SUBJECT: PUDSP-21-002 – Skyline at Lorson Ranch (with EGP)
First Submittal

Transportation / Traffic Impact Study

Skyline at Lorson Ranch Traffic Impact Analysis (LSC #204250) January 21, 2021

LSC Responses to TIS Redline Comments

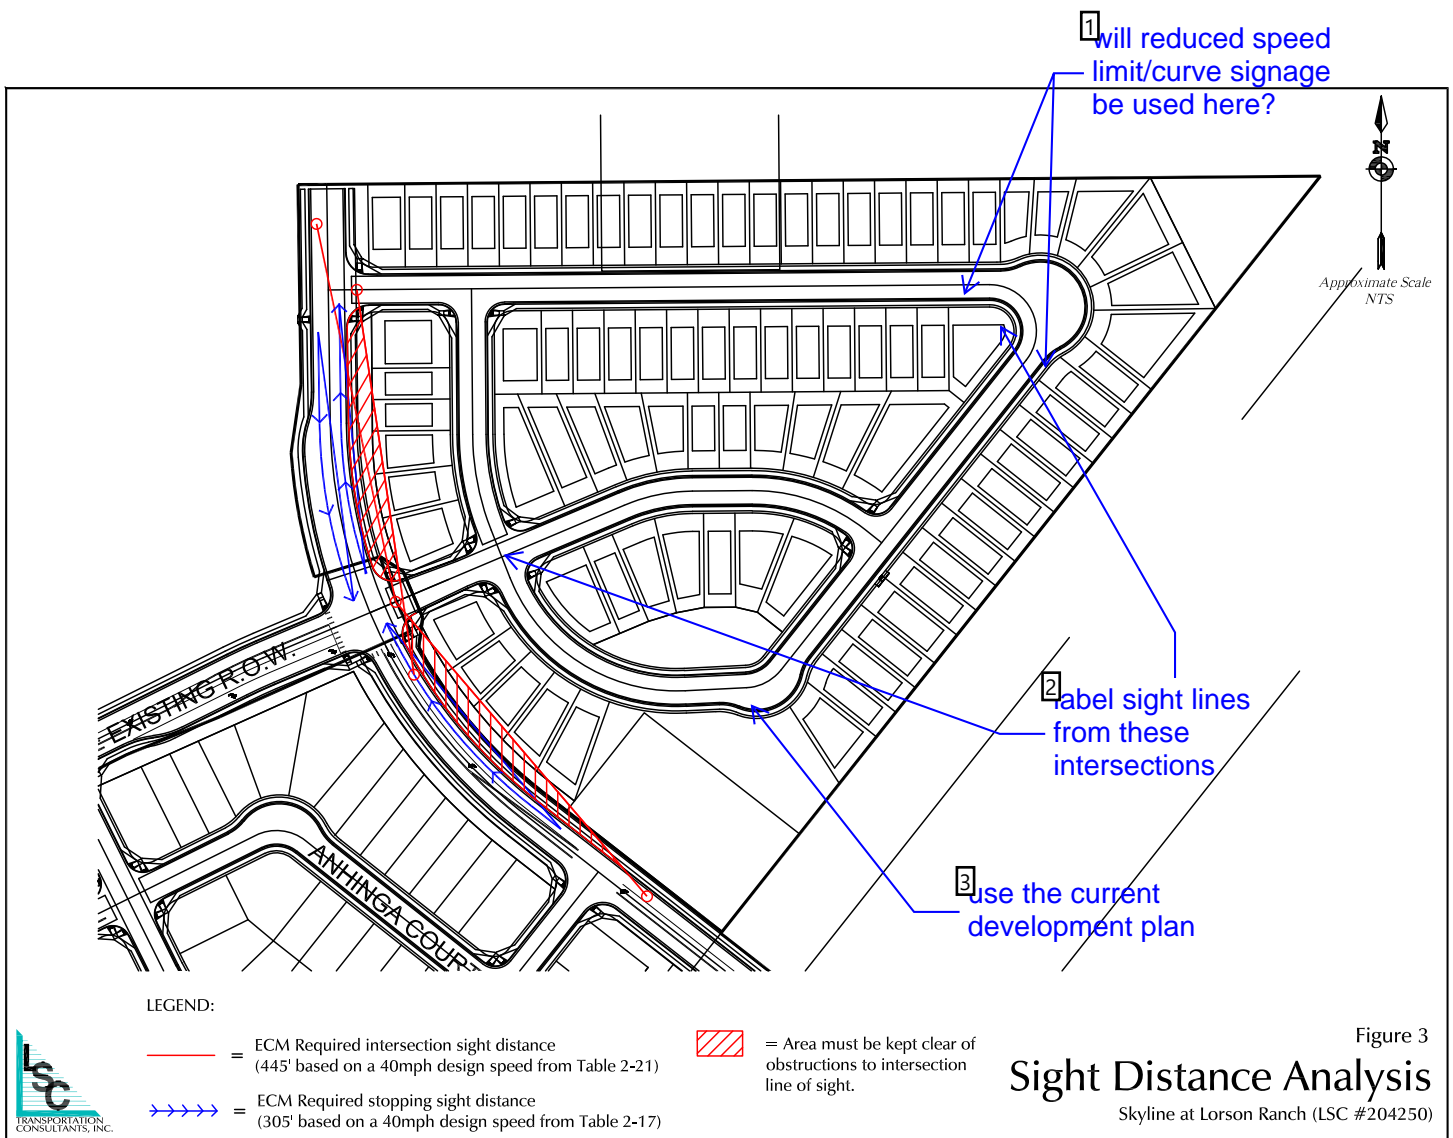
[will reduced speed limit/curve signage be used here?](#)

[label sight lines from these intersections](#)

[use the current development plan](#)

LSC Response: No, as the centerline radius meets ECM criteria for an Urban Local knuckle - thus the design speed is the same. The sight distance is addressed in the updated TIS report.

LSC Response: Added and addressed in the updated TIS report as requested. Also, sight distance easements have been added to the plan.

LSC Response: Updated as requested.

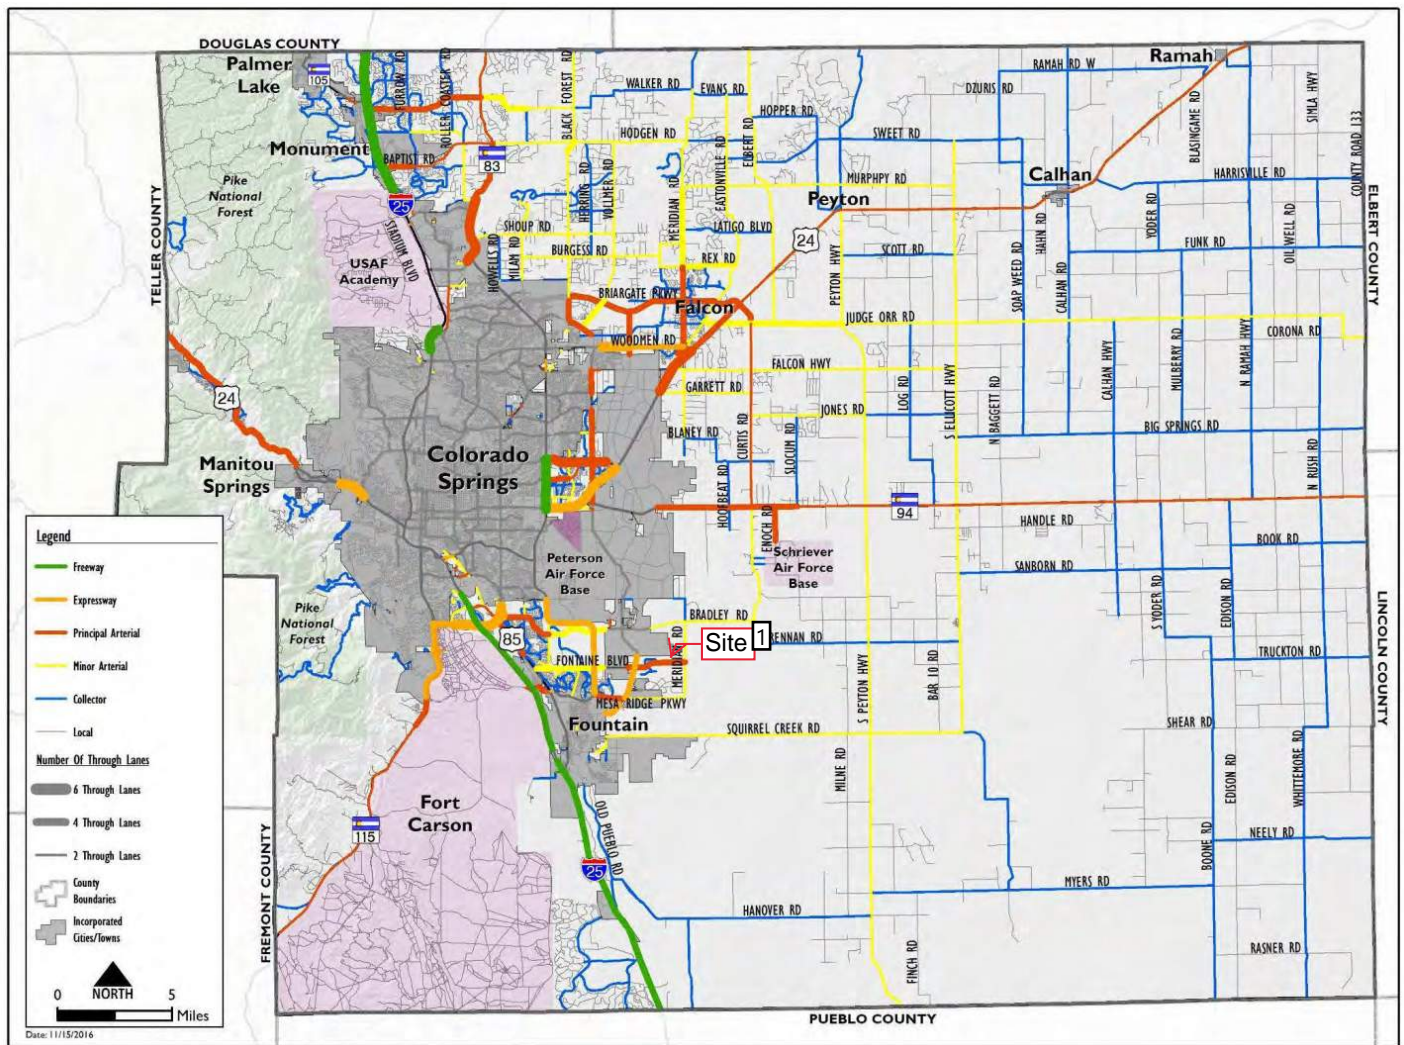
[add The Hills Memorandum \(TBD\)](#)

LSC Response: Added as requested.
